RFB for Pass-a-Grille Way North Washingtonia Palm Trees

November 22, 2016

Addendum 1: Questions Answered

PINELLAS COUNTY
DEPARTMENT OF ENVIRONMENT AND INFRASTRUCTURE
(D.E.I.)
TREE PROTECTION

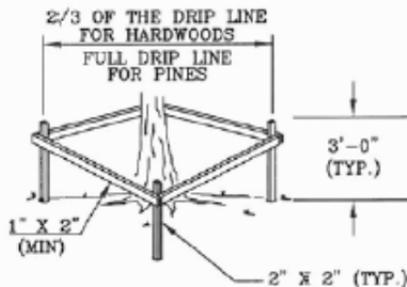
The lone detail included with the Project Plans which was inadvertently excluded from this bid package is attached to the following page of this addendum.
